AMENDMENT TO THE
REGIONAL WATER QUALITY
MANAGEMENT PLAN
GREATER KENOSHA AREA

JUNE 2012

RESPONSE TO REQUEST BY THE KENOSHA WATER UTILITY TO AMEND THE GREATER KENOSHA SANITARY SEWER SERVICE AREA

Map 1

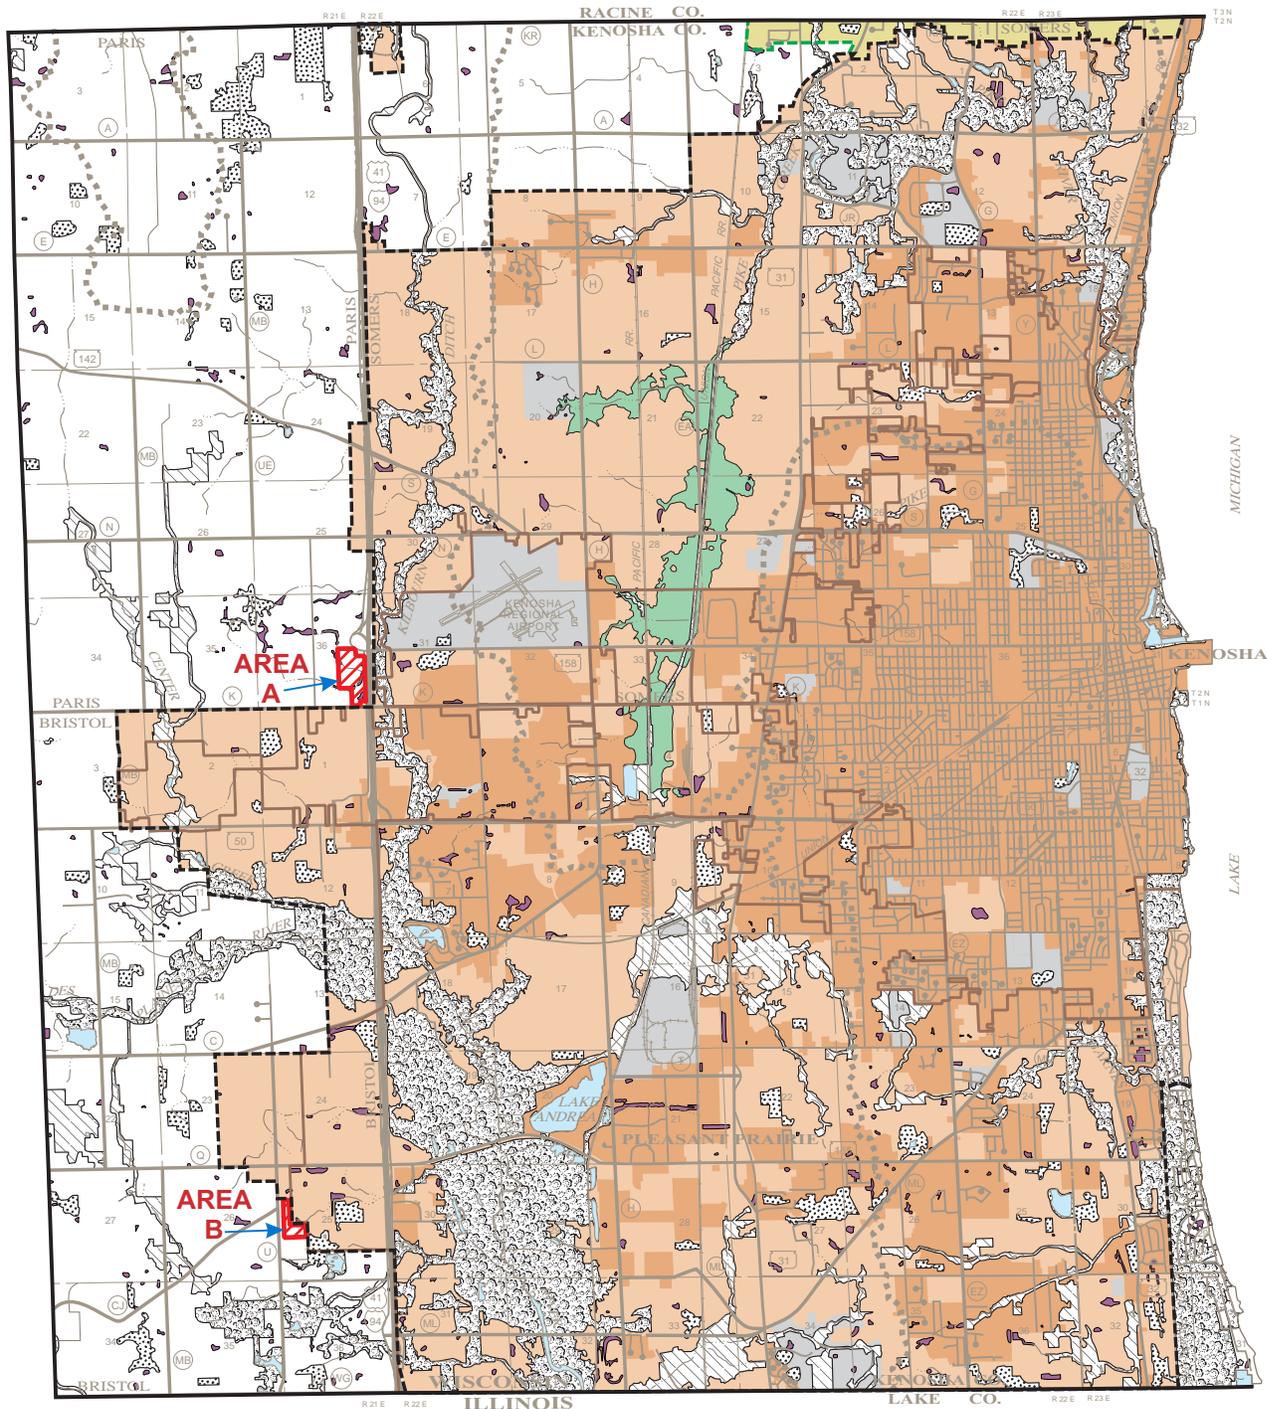
Two areas, designated Area A and Area B on Map 1, are proposed to be added to the Greater Kenosha sanitary sewer service area:

Area A encompasses about 59 acres located generally north of CTH K and west of IH 94 in the City of Kenosha. It includes about 14 acres of land located within existing street rights-of-way; five acres of small wetlands as identified in the Wisconsin Wetlands Inventory; and 40 acres of other open land. Area A does not encompass any lands that have been identified as environmental corridor or isolated natural resource area. It is envisioned that Area A would be developed for commercial use.

Area B encompasses about 27 acres located generally east of the intersection of CTH CJ and CTH U in the Village of Pleasant Prairie. It does not encompass any areas that have been identified as environmental corridor or isolated natural resource area, nor does it include any wetlands as identified in the Wisconsin Wetlands Inventory. It is envisioned that Area B would accommodate a large product distribution facility, which would be developed on Area B and land to the east of Area B.

Given all of the foregoing, it is recommended that the Southeastern Wisconsin Regional Planning Commission formally amend the Greater Kenosha sanitary sewer service area as documented in SEWRPC Community Assistance Planning Report No. 106, in the manner shown on Map 1. It is also recommended that the Wisconsin Department of Natural Resources approve this sewer service area plan amendment and certify the plan amendment through the Governor to the U.S. Environmental Protection Agency.

Map 2

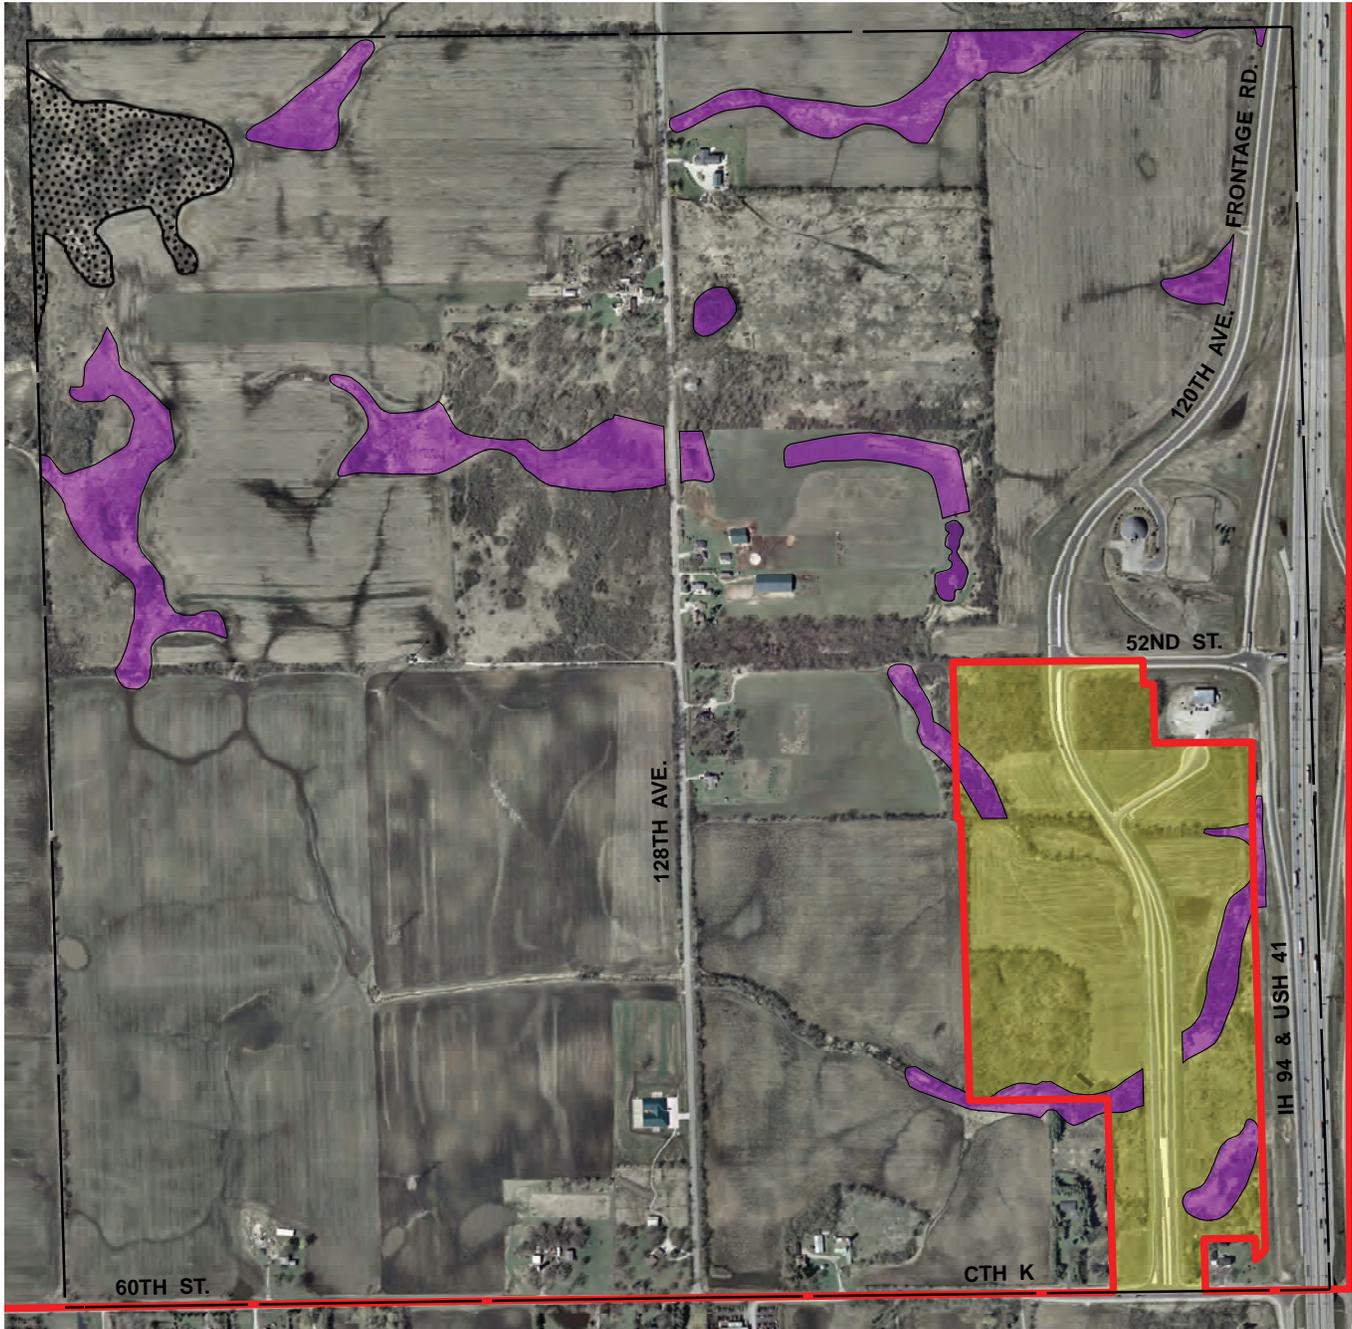
More detailed delineations of Areas A and B and of environmentally significant lands in the vicinity of each are shown on the aerial photographs reproduced as Maps 2 and 3. The environmentally significant lands shown on Maps 2 and 3 have been updated to reflect the most recent available natural resource and floodplain information.

NOTE: This map replaces a portion of Map 3-14, page 23, of SEWRPC Amendment to the Regional Water Quality Management Plan, Greater Kenosha Area, December 2001.

Map 3

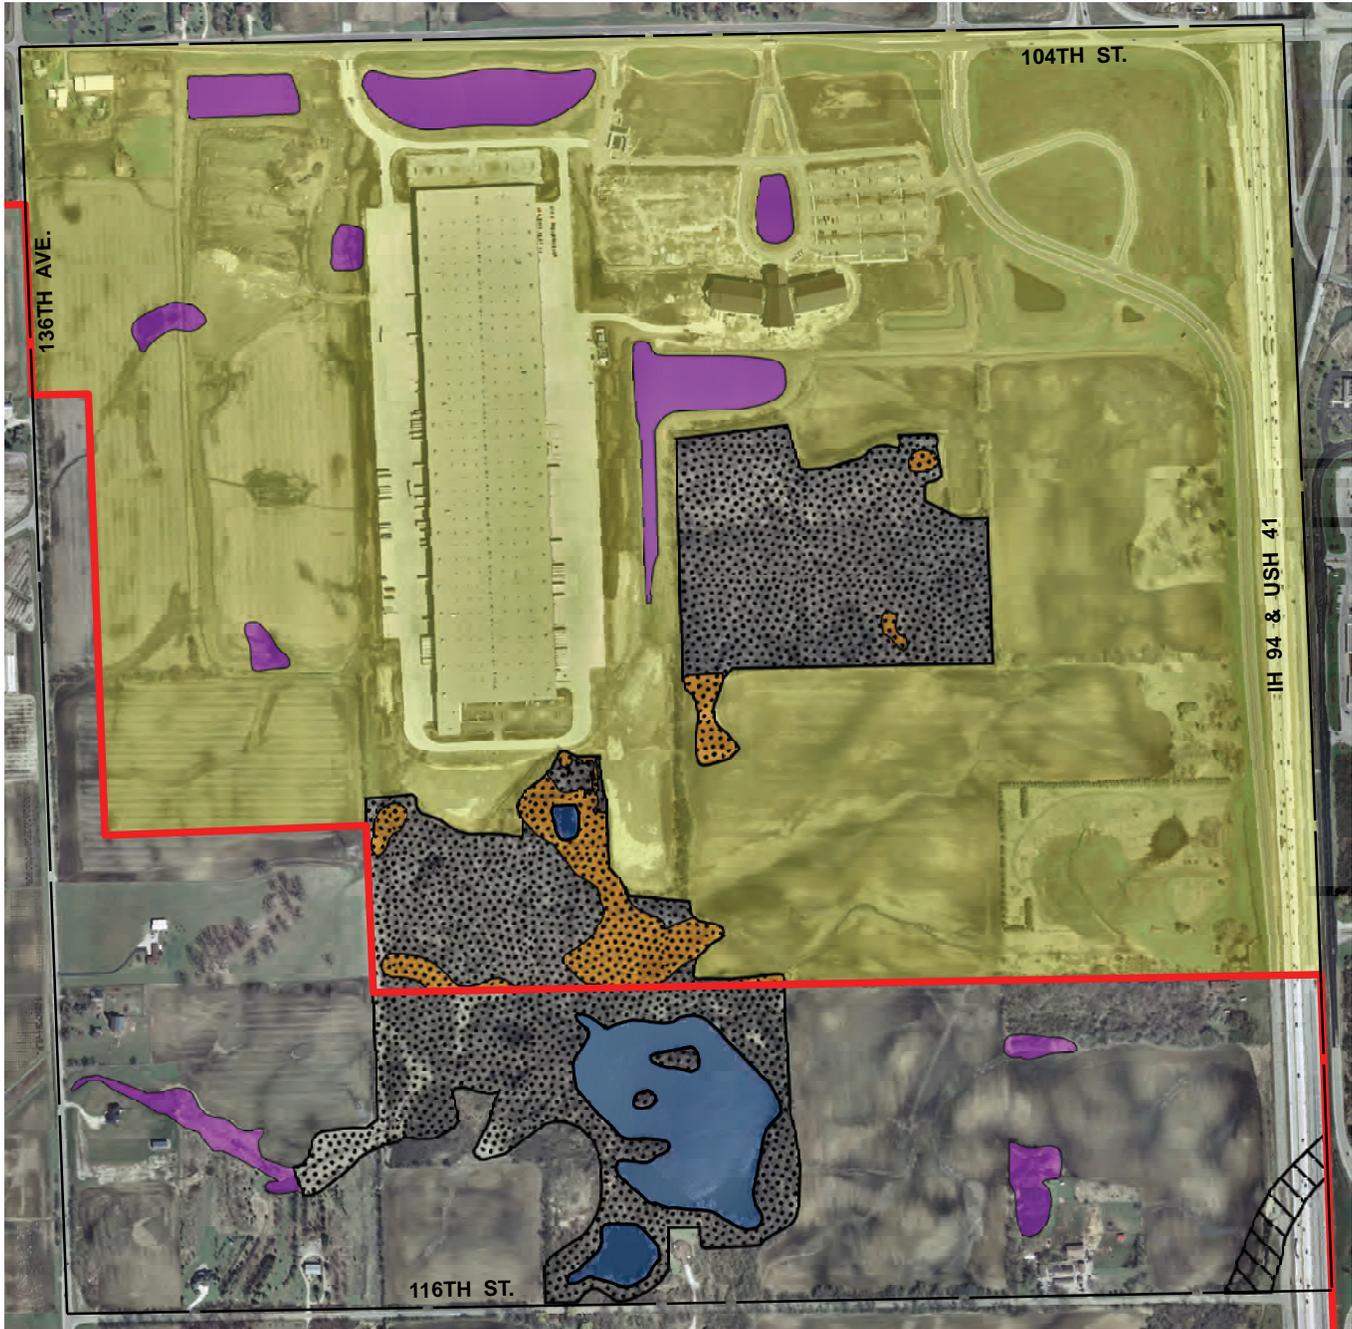
NOTE: This map replaces a portion of Map 4, page 7, of SEWRPC Amendment to the Regional Water Quality Management Plan, Greater Kenosha Area, June 2007.
